July 24, 2024

**From:** Marina Tadenc, Cliffcrest Scarborough Village SW Residents Association  
**To:** Councillor Parthi Kandavel, Lou Di Gironimo, Jennifer Graham Harkness  
**cc:** Paul Vincent, Alexandra Kyriakos, GraceTesa, Ariella Barmash

**Subject:** Follow Up to May 23<sup>rd</sup> Toronto Engineering Meeting with regards to 3291 KINGSTON RD/2-4 WINDY RIDGE DR - Application Number:20209863ESC20OZ

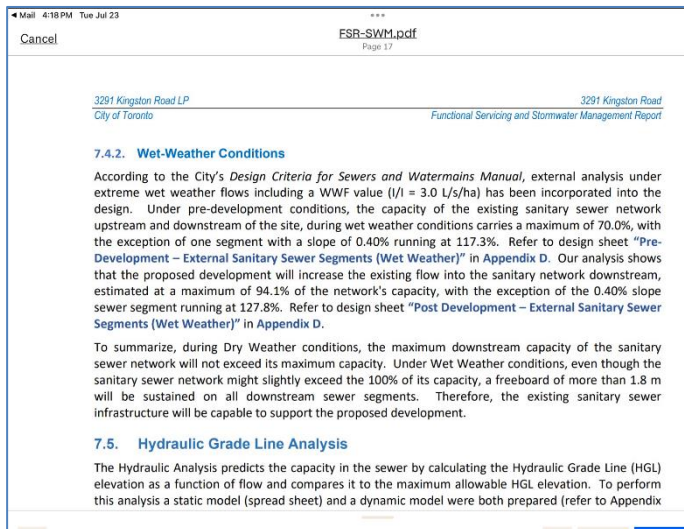
Following are screen captures indicating upgrades are needed where this development is being proposed.

Given the INTENSE RAIN EVENT on JULY 16<sup>TH</sup> and that the Area 52 Study is **not accounting** for the addition of many **new condo builds** along Kingston Road and potential EHON infills in our neighbourhoods, which are

removing permeable surfaces, changing our watershed, and putting new pressures on the existing storm sewers infrastructure **we want to understand how** Engineering and Construction Services is satisfied with those engineering reports for the purposes of the zoning by-law amendment.

The project team confirmed on July 19, 2024 that new developments are not considered in their review, *“This BF Study is a separate and distinct process from new development application review process, where new housing developments must meet City standards to provide for sufficient stormwater drainage management and sanitary sewer capacity prior to being approved.”*

They also confirmed that as of right now, there is no funding or prioritization for the BF Study recommended solution. It still needs to go to council.

The image of TRCA maps shows in purple TRCA regulated Lands, In yellow the subject site for a 360-unit mid-rise building proposal.

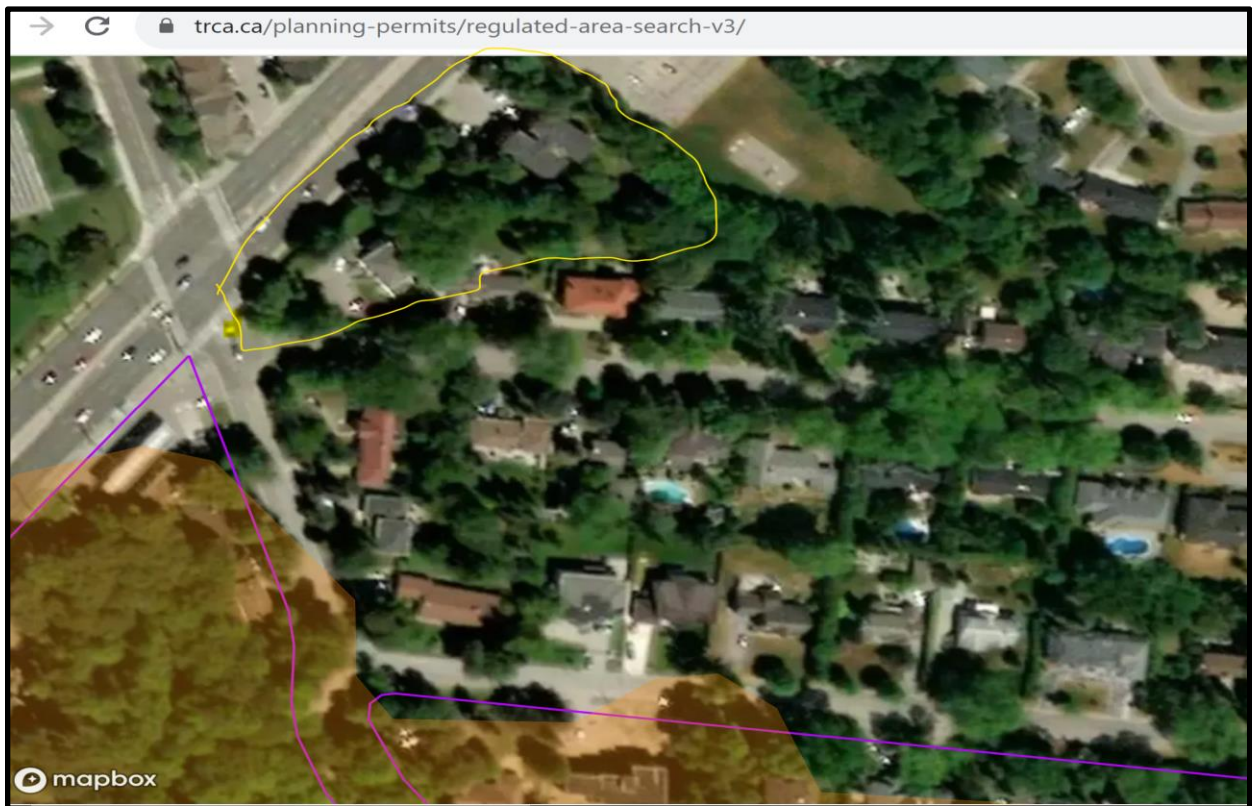
4. **Environmental Impact** - Given the subject site and TRCA lands are "upstream" by the way the waters flow and the site sit directly in migratory path of many species of birds to the lake. Please confirm what the change of removing water that currently flows downstream will have no impact to the sensitive environment and that there is no need to engage with TRCA to determine if each development will have a negative impact.
- a. Neither the City or TRCA will not acknowledge and confirm the proximity of the developments being proposed to TRCA lands?
  - b. We have asked but had no response as to how is the City adhering to Official Plan, Chapter 3, Section 3.4 regarding a Natural Heritage site and buffer zone? (see **"NOTE 2"** below for more detail)
